BHADRADRI THERMAL POWER STATION
4 X 270 MW, UNITS-1 TO 4, MANUGURU, TELANGANA, INDIA

TITLE :
TYPICAL CROSS SECTION OF CONVEYOR GALLERY & TUNNELS

Compliance report		
4 x 270 MW Bhadradi TPS - Coal Handling System		
Drg/Doc no: IS-1-GA-691-100-M003 Rev00		
Drg/Doc title: Typical Cross Section of Conveyor Gallery & Tunnels		
Sl no	Customer comment	BHEL reply Dtd: 25-06-15
TSGENCO / DESEIN COMMENTS DTD: 08-06-2015		
1	Please provide a gap of 300 mm instead of 500 mm from top of the gallery and a gap of 150 instead of 200 from bottom of the gallery.	Gap of 500mm from top of the gallery is maintained in line with TSGENCO specifications. And, gap of 200 from bottom of the gallery is maintained in line KOTHAGUDEM project where drg. is already approved by TSGENCO.
2	Please provide lights on the walkway instead of providing the same on conveyor.	Noted & incorporated.
3	Please provide 3.15 mm thick seal plate and deck plate instead of 3mm thick.	Noted & incorporated.
4	Please indicate the elevation of pipes, grade of handrail, detail of drains & its cover details.	Elevation of pipes and drains & its cover details shall be indicated in respective civil/structural during detail engineering. A

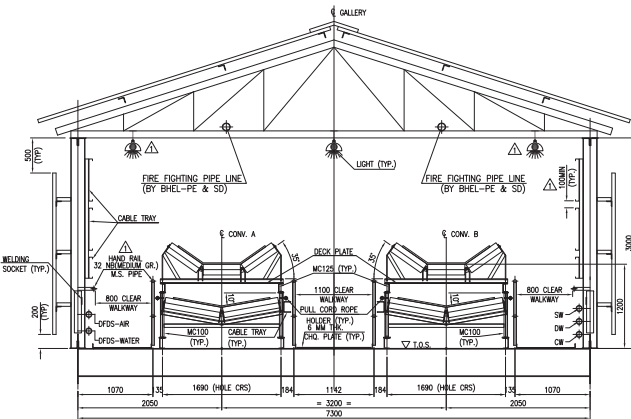
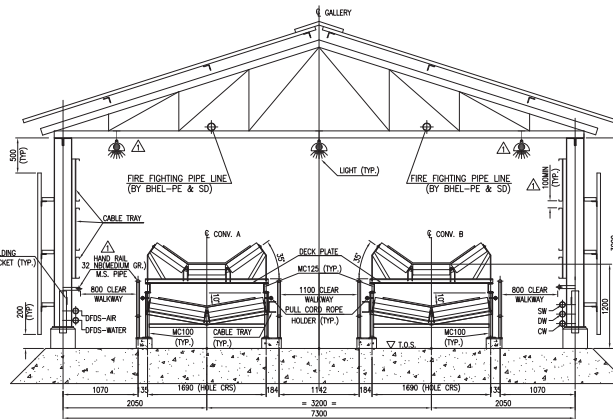
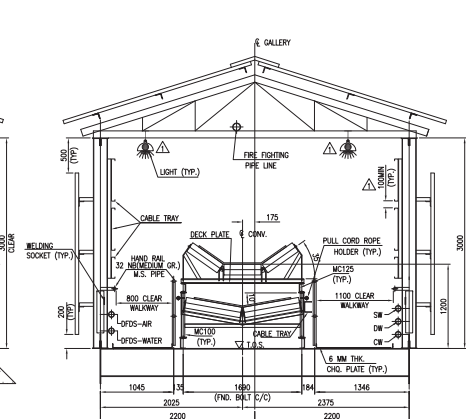
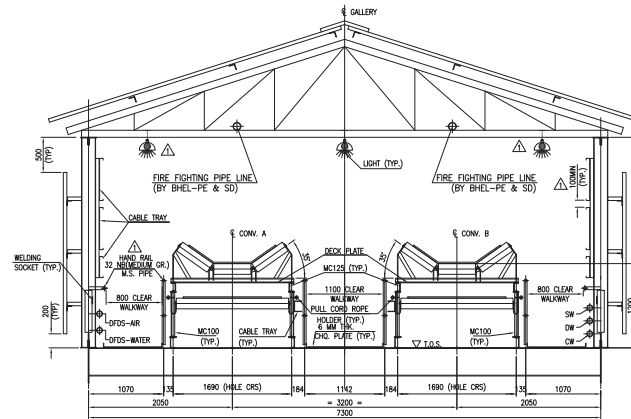
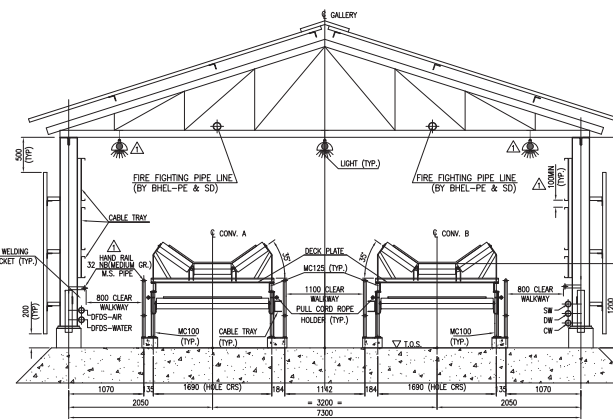
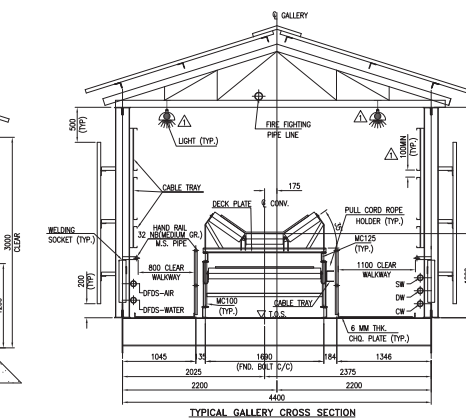
5	Please mark supply and exhaust ducts and fix the lights on the same.	Noted & incorporated.
6	Please provide a note regarding distance of trays.	Noted & incorporated.
